# Environmental Impact Report

## Altamont Sanitary Landfill

**Conditional Use Permit C-3010**

## **Volume Two**

DETAIL "B"

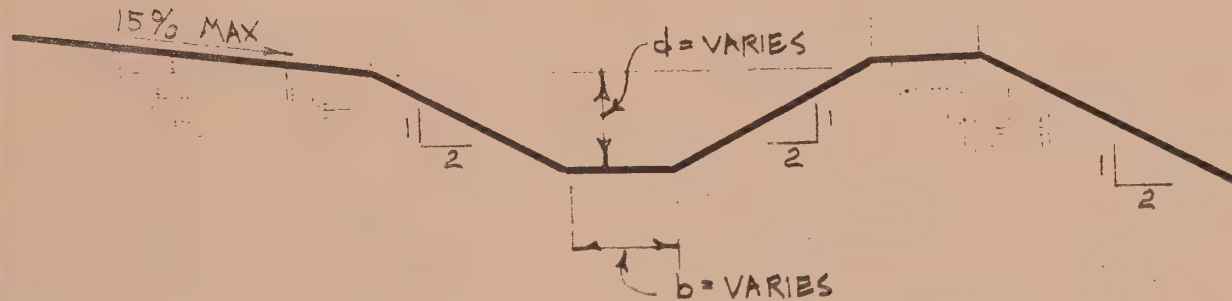
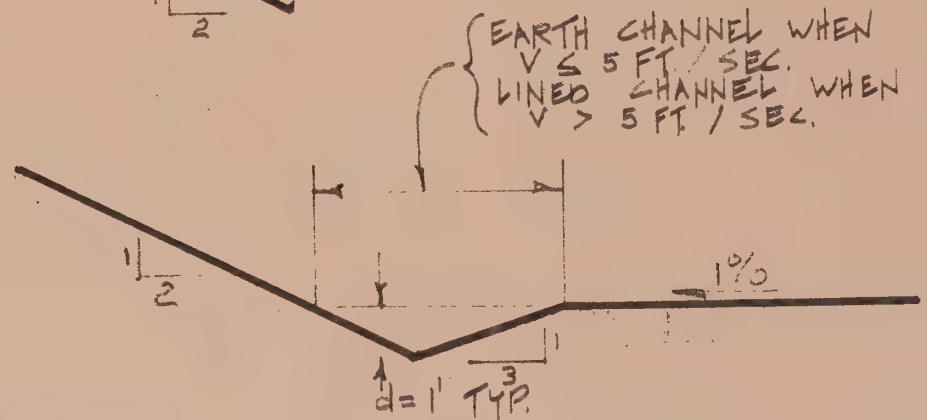
2. Our review of the report did not encounter a discussion of the erosion of the landfill surface by surface runoff. It might be expected that some erosion of the surface could occur during periods of intense rainfall. Erosion of the landfill could cause sedimentation to occur downstream of the project site. The EIR should discuss the potential for erosion and downstream sedimentation, and the means which may be used to mitigate this potential impact. The details of the plan, presented on page 12, indicate that some measures would be incorporated into the project. The description and presentation of Details "A" and "B", alluded to on page 12, might suffice.

As shown by the details on Pages 6 and 7 of this Addendum, surface runoff will generally be handled by triangular or trapezoidal shaped drainage ditches located around the periphery of the fill areas, and by pipe systems where slopes become steep and significant erosion could occur, such as down the face of the fill. In general, runoff from adjoining hill-sides will not be allowed to run onto the fill, except in special circumstances where permitted by the Regional Water Quality Control Board. Ditches will be lined where runoff velocities become erosive (more than approximately 5 feet per second). Typical drainage details at the top of a typical fill face and at intermediate benches were referred to on Page 12 of the Draft EIR, but were not illustrated. These details are shown on Page 9 of this Addendum.
